MURRIETA VALLEY UNIFIED SCHOOL DISTRICT  
MVUSD ASPHALT REPLACEMENT, SLURRY & RESTRIPE PROJECT

BID # 04052018-01

**ADDENDUM # 1**

A-10

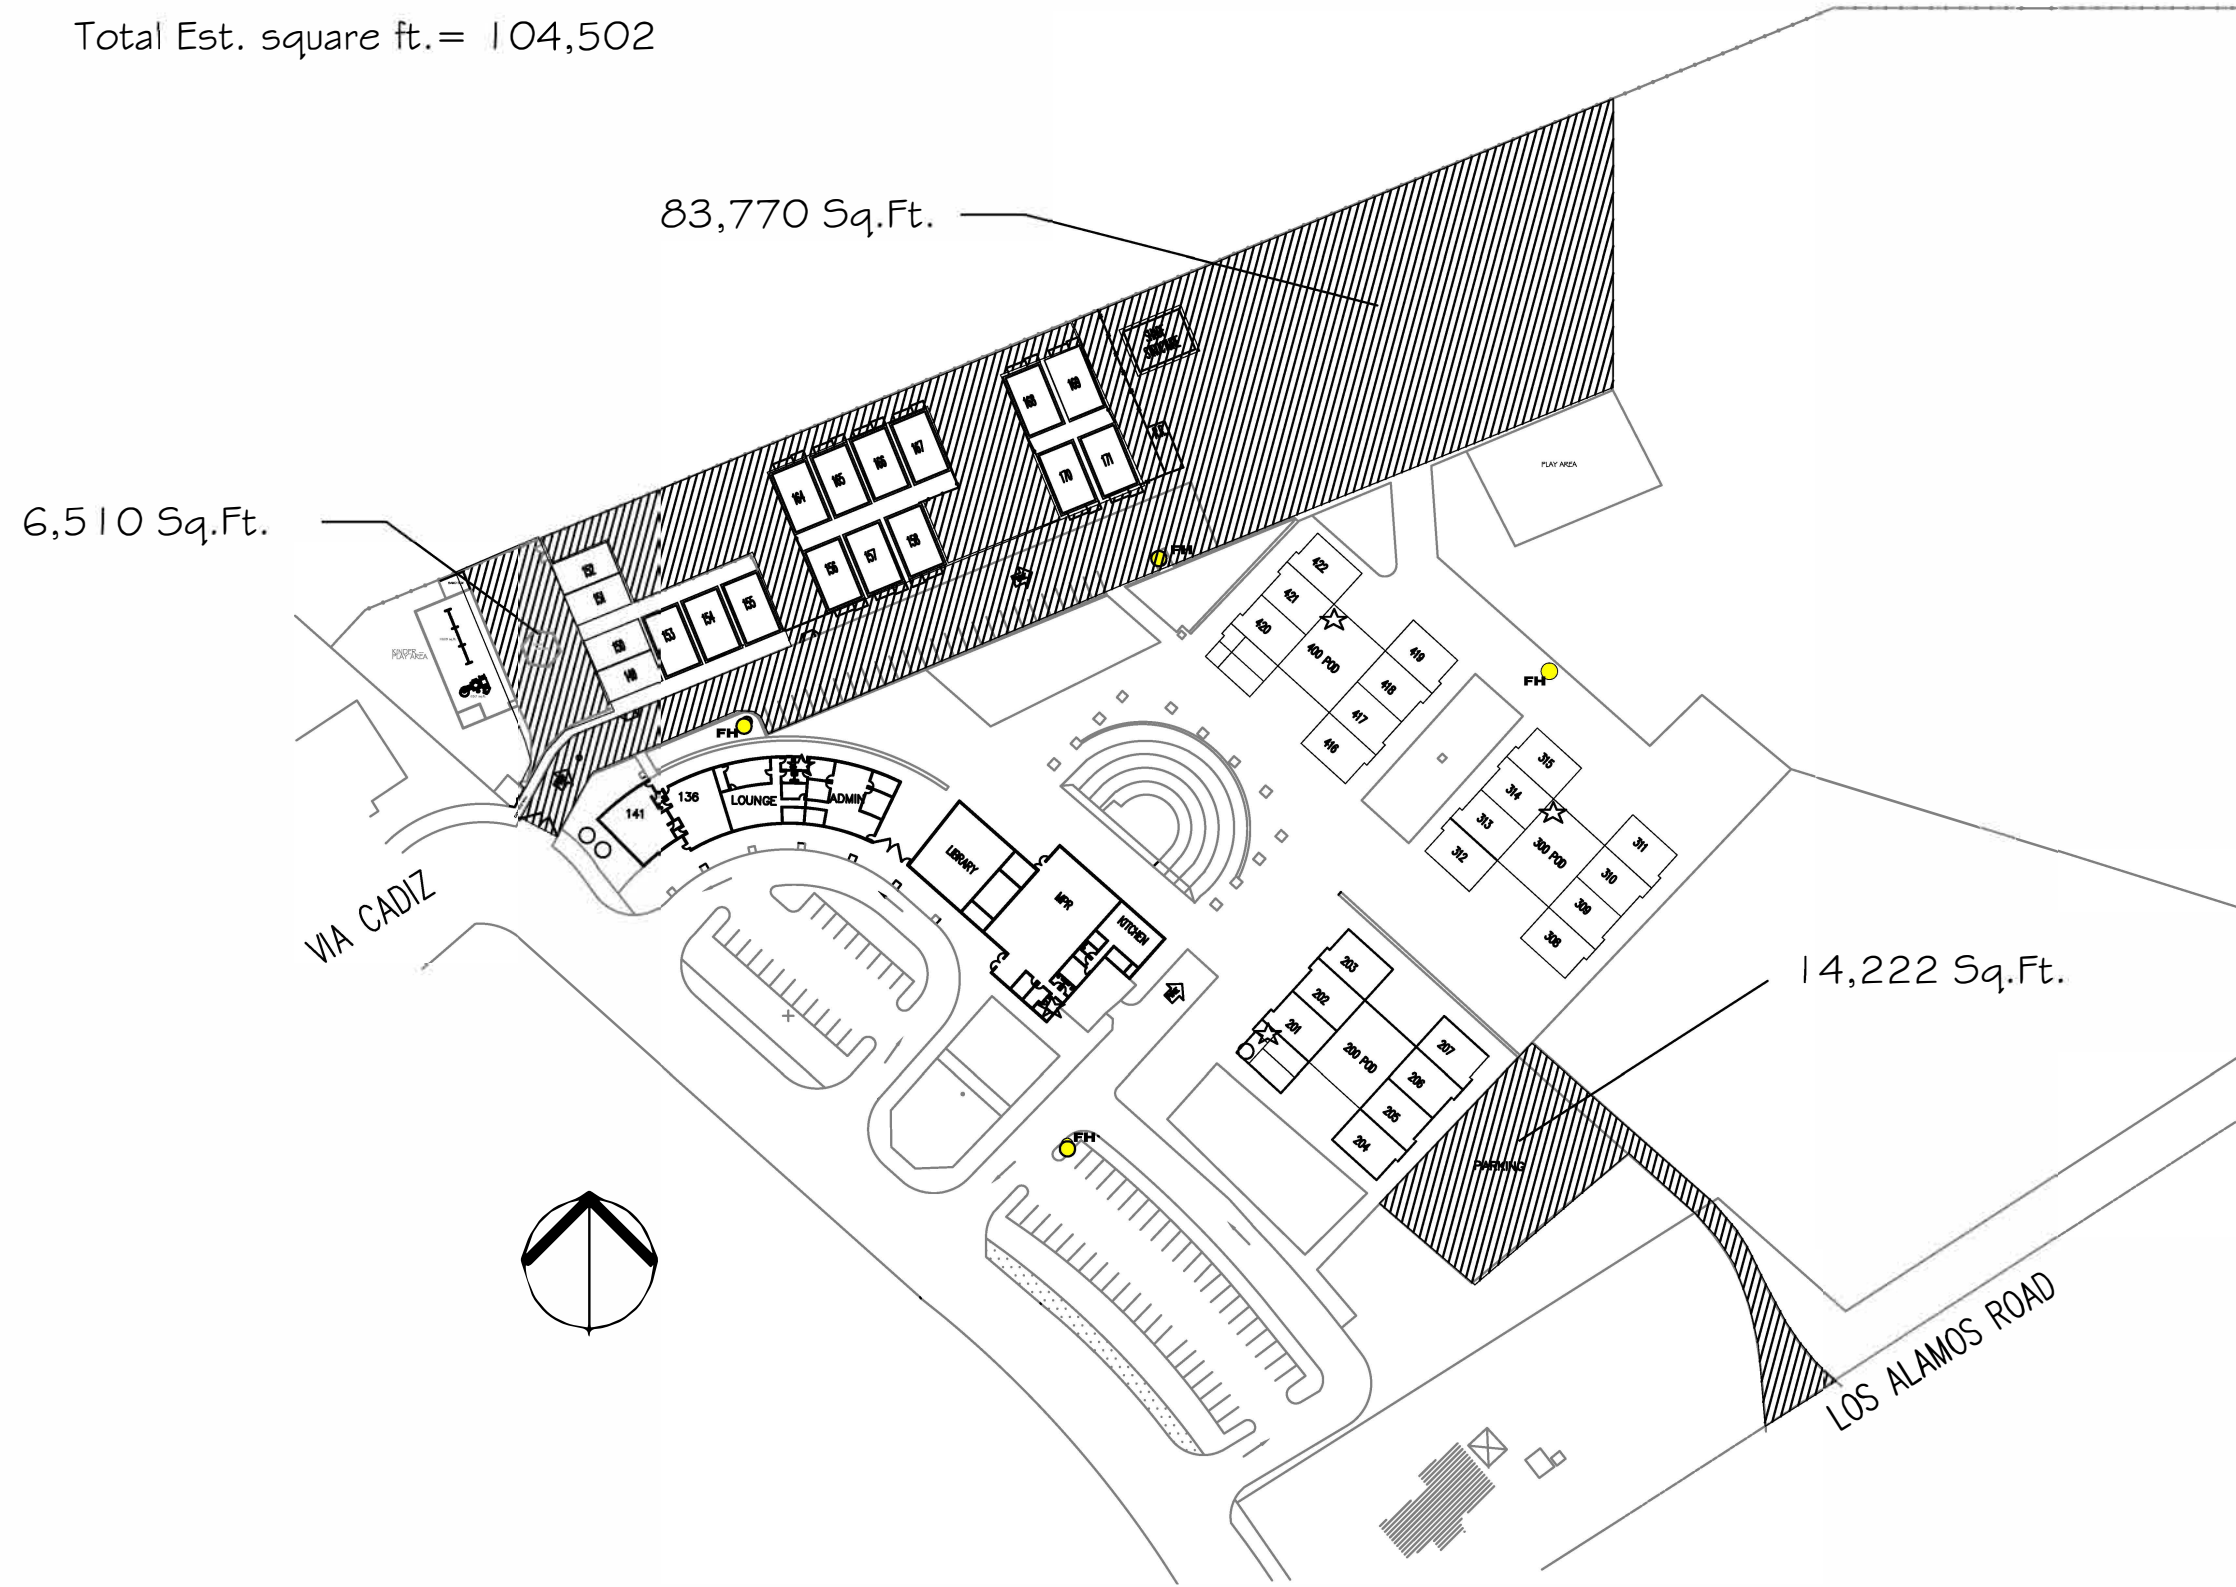
1. Rail Ranch Elementary School Propose square footage 104,502

1. A-10 Rail Ranch Elementary School - Map Updated for Square Footage
2. A1.2 Vista Murrieta High School Map - Revised to Vista Murrieta High School Map# A-20

Total Est. square ft. = 104,502
